SEWAGE DISPOSAL TESTING

MARYLAND STATE DEPARTMENT OF HEALTH

PROPERTY OWNER Robert Johnsen

SUBDIVISION (Plat of Robert Johnsen) LOT NO. 2

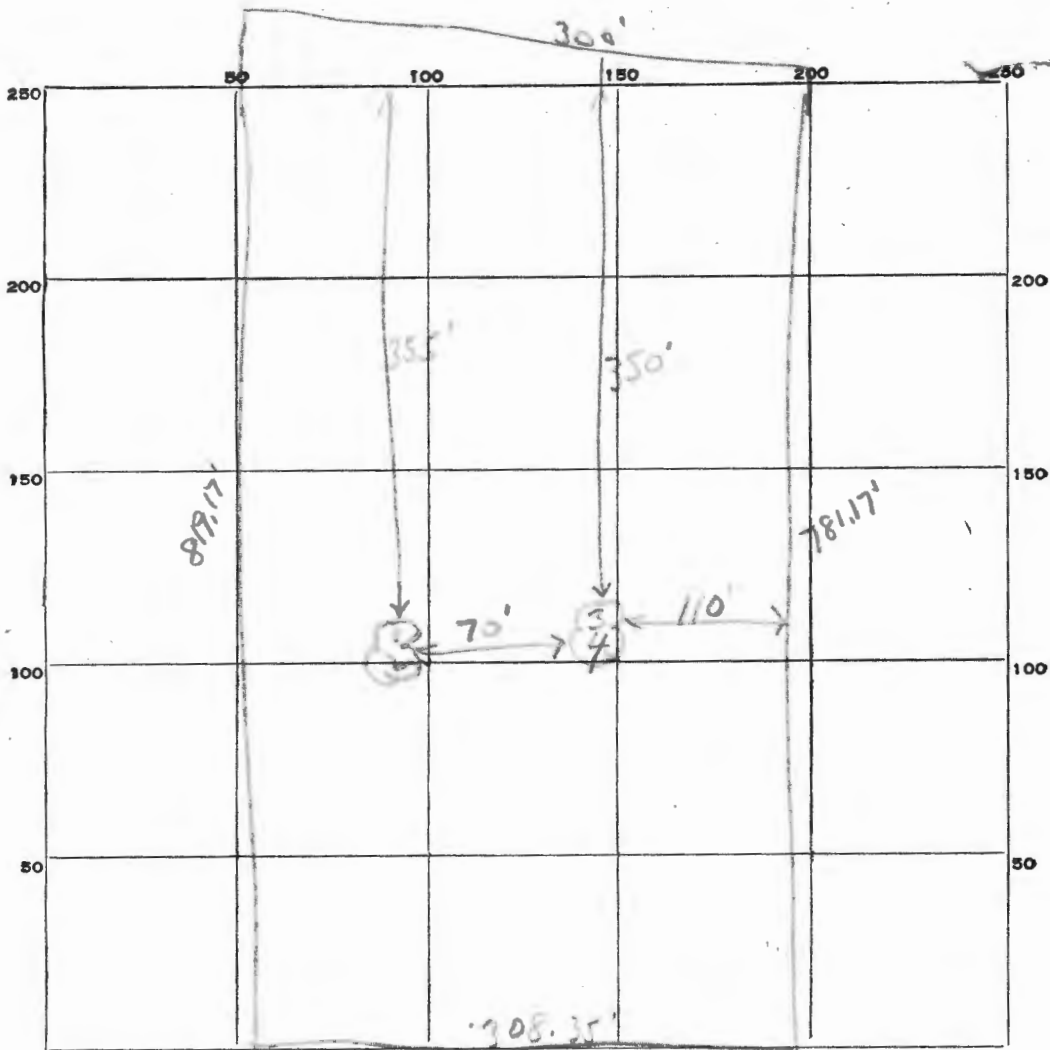
*Visual hole  
14' deep needed  
down.*

*below the first 5 ft of original grade located approximately 355 ft from rear lot line and 150 ft from right side lot line as seen when facing lot from Jennings Chapel Rd*

Dry well - 480 sq. ft absorbent sidewall area below the first 5 ft of original grade located same as above.

APPROVED BY JH Kubmae FOR Dry well DATE 6/21/66  
(KIND OF SYSTEM)
